FULTON & FILLMORE

1-30-17

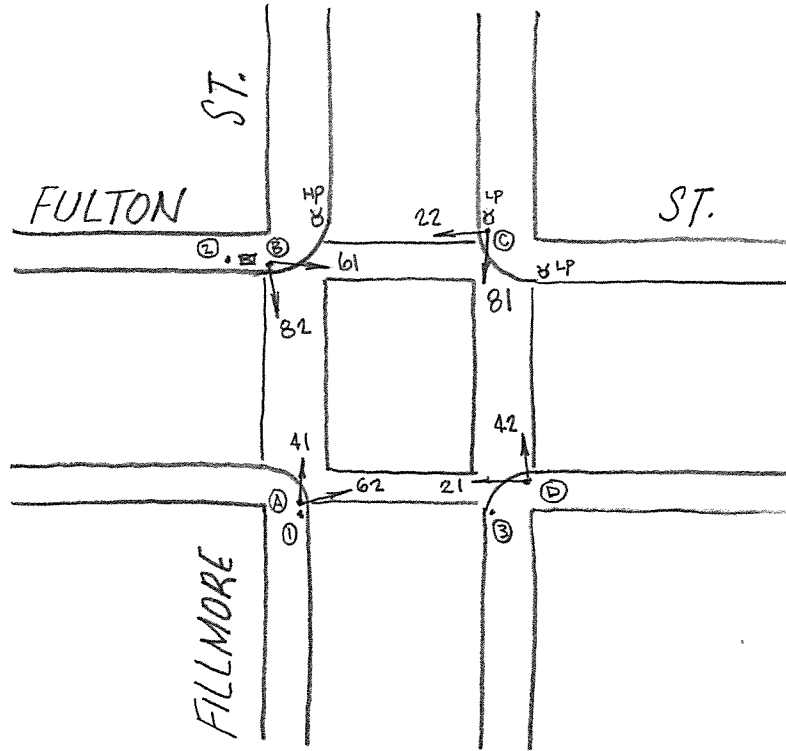
COMMENTS: Upgrade all vehicle signals to 12", per SRC 2016-342. JOK
